34<sup>th</sup> Street Pump Station Improvements Project  
SAWS Job No. 13-6004  
Solicitation No. CO-00072-RA

**ADDENDUM No. 2**

October 14, 2016

**GRATING SUPPORT LAYOUT**  
SCALE: 1/4"=1'-0"

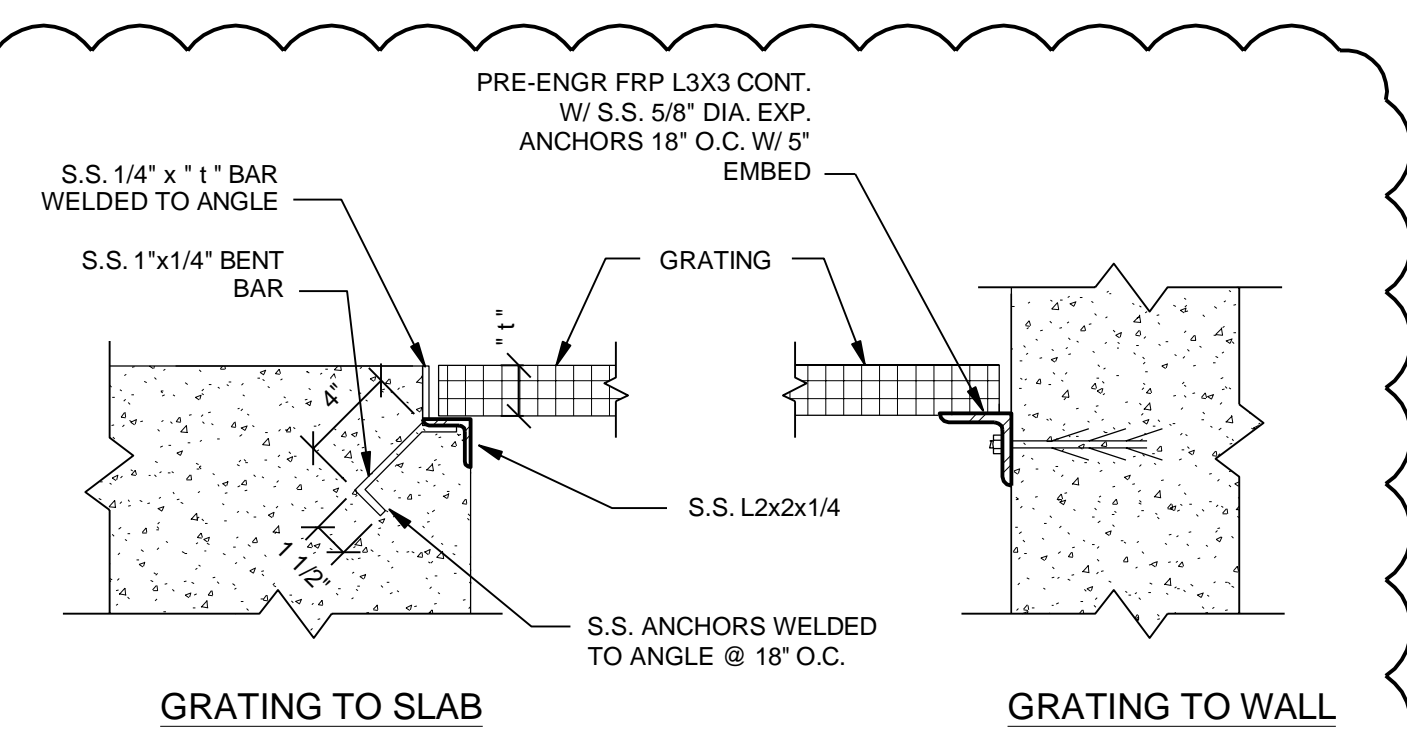
Revised grating support layout detail to include FRP supports instead of Aluminum.
